STATE OF NORTH CAROLINA
DEPARTMENT OF TRANSPORTATION

Subject: **Modification and Reverification of Regional General Permit 50 & 401 Water Quality Certification** for the Replacement of Bridge No. 67 on US 25/70 over the French Broad River in Madison County, Division 13, TIP No. B-5895, WBS No. 48088.1.1

TEMPORARY ROCK CAUSEWAY PHASING PLAN

PERMIT DRAWING
SHEET 4 OF 6

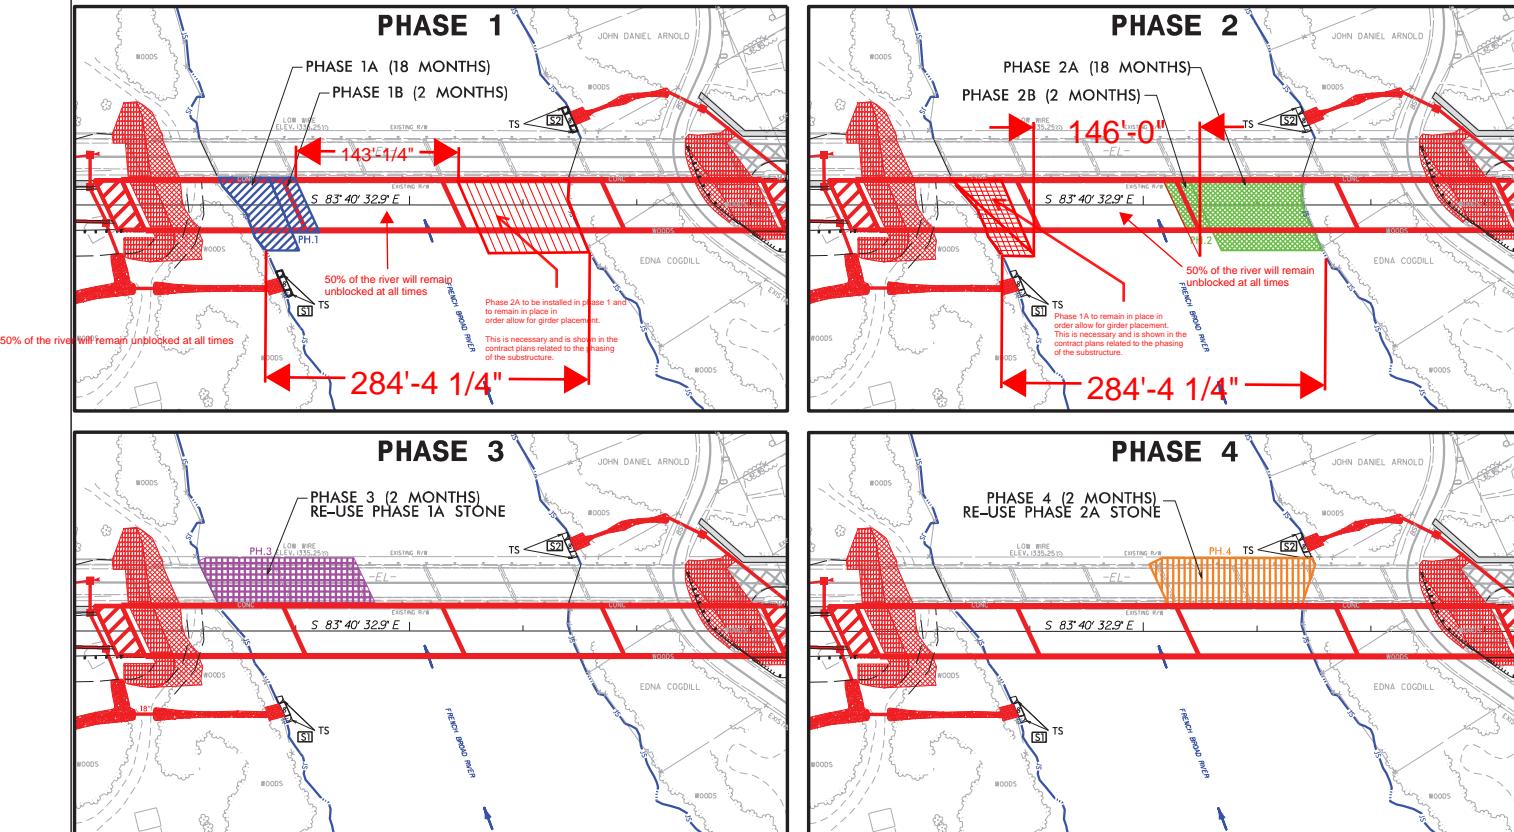
NCDOT has determined that a modification to the temporary rock causeway phasing plan will be necessary to construct Bridge 67: The causeway footprint for project B-5895 (SAW-2022-02178) will remain unchanged, however the phasing/timing of causeway placement needs to be adjusted in order to accommodate the equipment needed to properly set the interior girders of the proposed structure (requiring modification of 404 verification due to a change in plans). This adjustment in causeway phasing will not restrict more than 50% of the river at any one time or change the originally authorized impact totals to the French Broad River (Revised Phasing Plan, attached).

- 1) Phase 1A and 2A would be installed and remain installed during phase 1 and phase 2 to allow for girder erection.
- 2) Phase 1B and 2B will not be installed during the same time to allow for at least, if not more than, 50% of the width of the river to remain open at all times.
- 3) The Construction times shown would remain unchanged and as shown are approximate according to existing note 5.

Exhibit 1

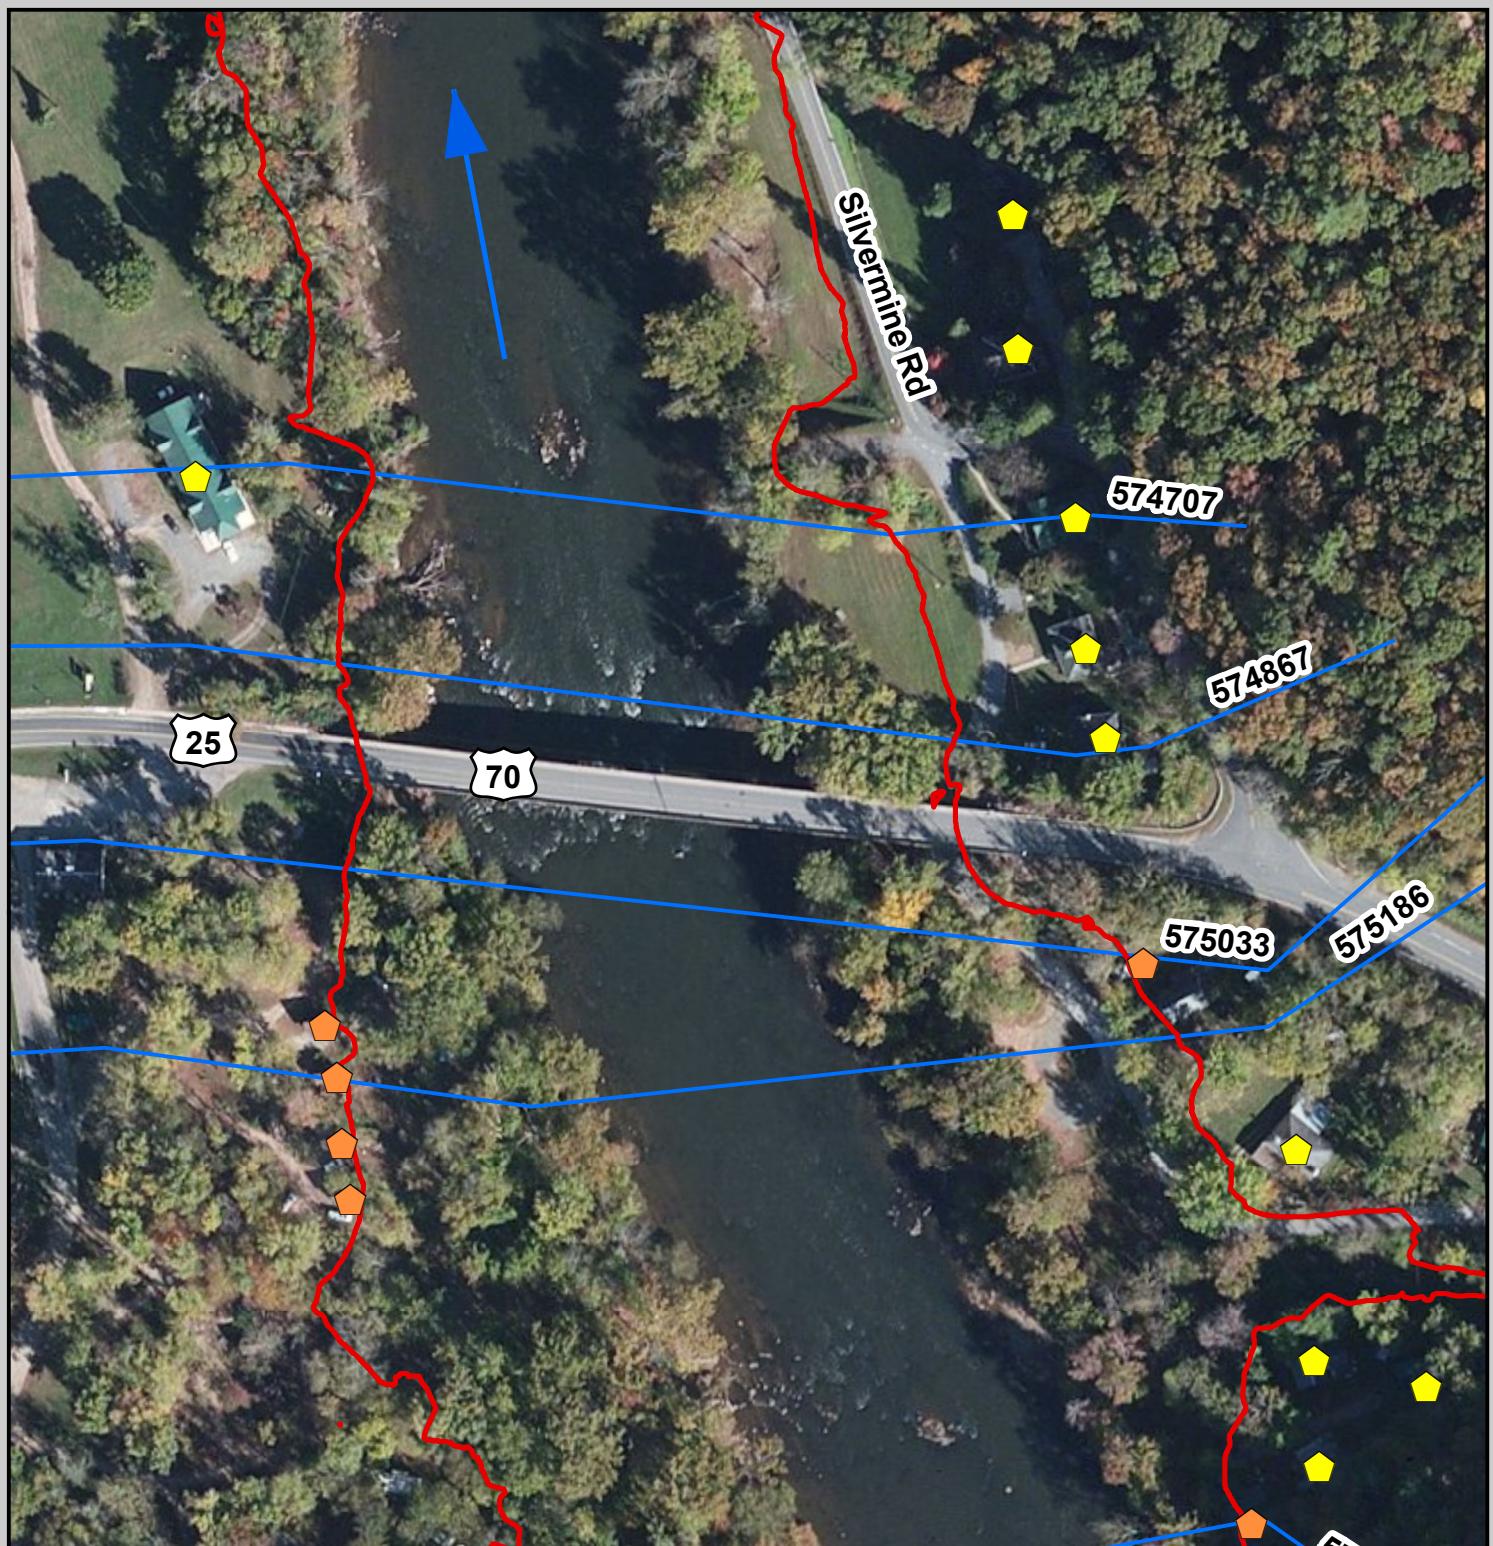
As a result of this alteration to causeway phasing, an updated floodplain impact analysis was conducted. This resulted in an estimated increase in the 10 year flood event of 0.5' (to a new max increase of 1.6' in water surface elevation, as shown in Table 1 of the attached Floodplain Analysis). This projection did not result in any additional properties being impacted other than those already notified.

There are several structures, primarily residential, within the floodplain upstream of the bridge that could be impacted by increases in WSE during construction. To determine the potential impacts to these structures, a hydraulic model was created in the US Army Corps of Engineers Hydraulic Engineering Center's River Analysis System (HEC-RAS). The most constricted condition that occurs during Phase 2 was modeled to determine the highest expected WSE increase during construction. The two-year, five-year, and ten-year flood events were evaluated. These events were selected due to the anticipated duration of construction. A maximum increase in WSE of 1.6 feet occurs approximately 256 feet upstream of the bridge at River Station (RS) 575186 during the ten-year flood event. The results of the HEC-RAS model are shown in Tables 1 and 2. Table 1 reports the WSE for the existing condition and the increase change in WSE created by the constricted condition. Six residential structures are impacted by the increase in the ten-year flood event. These structures are identified in Exhibit 1. Four of the structures are cabins in the Hot Springs Campground on the west side of the river. These cabins are elevated with the finish floor above the ten-year WSE. The other two impacted structures are on the east bank of river along Silvermine Road. The ten-year WSE during construction could reach the lowest adjacent grade of these structures but is not expected to reach the finish floor elevation. The extent of these impacts is shown in Exhibit 1. Table 2 reports the impacts of the causeway constriction on channel velocities.
